Subject: Compliance Recall 04V-602
(Ford Number 04C09)

SUBJECT: Compliance Recall 04C09 - Supplement #1: All 2004 and Certain 2005 Model Year Escape Vehicles built, and Certain 2001-2003 Model Year Escape Vehicles serviced with subject Latch Assemblies - Liftgate Latch Release Rod and Handle Assembly Return Spring Replacement

Compliance Recall 04C09 - Supplement #1:

FIGURE 5

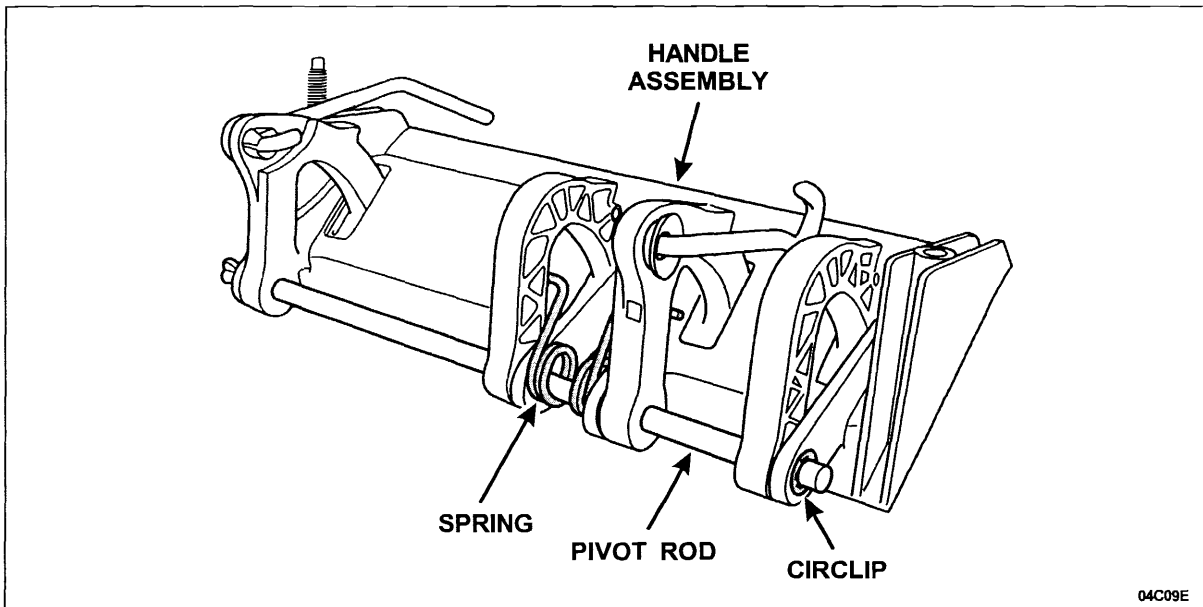
9. Disassemble the handle as follows:
 - a) Remove the circlip from the end of the pivot rod.
 - b) Pull the pivot rod out of the handle assembly.
 - c) Note the position of the spring then remove the spring from the handle assembly.
10. NOTE: The **new** circlip is supplied in the bag with the **new** spring. Make sure to retain the **new** circlip for installation to the original pivot rod and handle.
Install the **new** spring and circlip to the original pivot rod and handle.

FIGURE 6

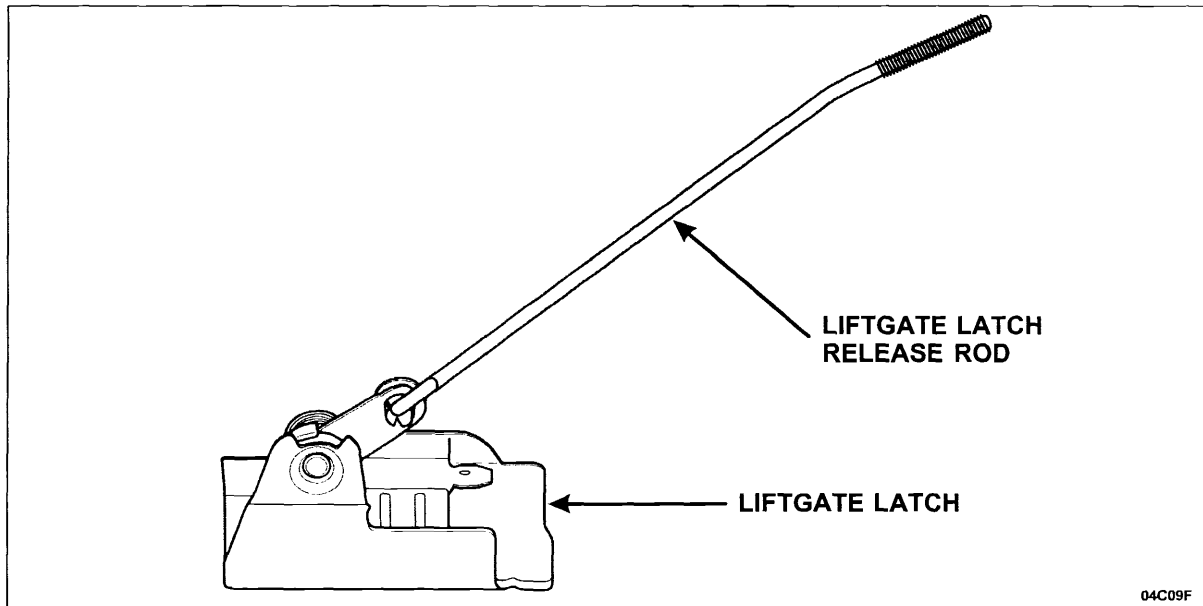
1. Open the liftgate.
2. If equipped, remove the rear wiper motor cover.
3. Remove the four (4) screws and remove the liftgate trim panel.
4. Disconnect the liftgate ajar switch electrical connector (located on the liftgate latch).
5. Remove the three (3) liftgate latch bolts and retain.
6. Remove the liftgate latch.
7. Remove the liftgate latch release rod and install the *new* rod. See Figure 6.

8. Remove the original release rod clip and replace with the *new* clip.
